**XLC Second Stage Retrofit Service Advisory**

**Attention all Authorized Aqua Lung Dealers:**

**OLD STYLE (1998)      NEW STYLE**

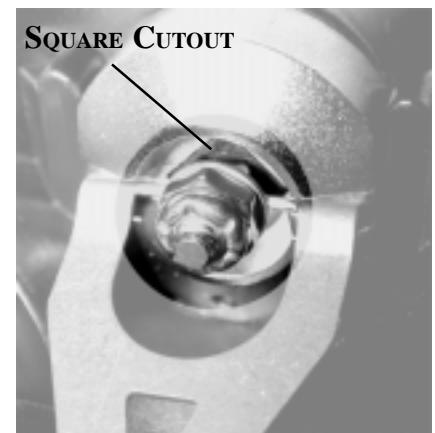
The XLC has a black poppet bearing associated with the valve insert. The first units released in 1998 had a poppet bearing that loaded from the front of the valve insert. At the beginning of 1999, a design change was incorporated that featured a rear-loaded bearing instead (see illustration).

We now want to step up the efforts to get the remaining older style inserts and bearings out of the field. We have recently discovered that in rare cases, a spike in intermediate pressure from a poorly performing first stage can lead to the removal of the lever in XLCs that have the older configuration. If the lever were to become dislodged during a dive it would terminate the air supply and cause the diver to use their alternate air source or turn to their buddy for air.

If you find an older version, please service the unit with the 900010 XLC service kit. This service kit contains the new style valve insert / bearing. Please call our Customer Service Dept toll free at 877-253-3483 and we will be glad to replace, free of charge, any kits you use.
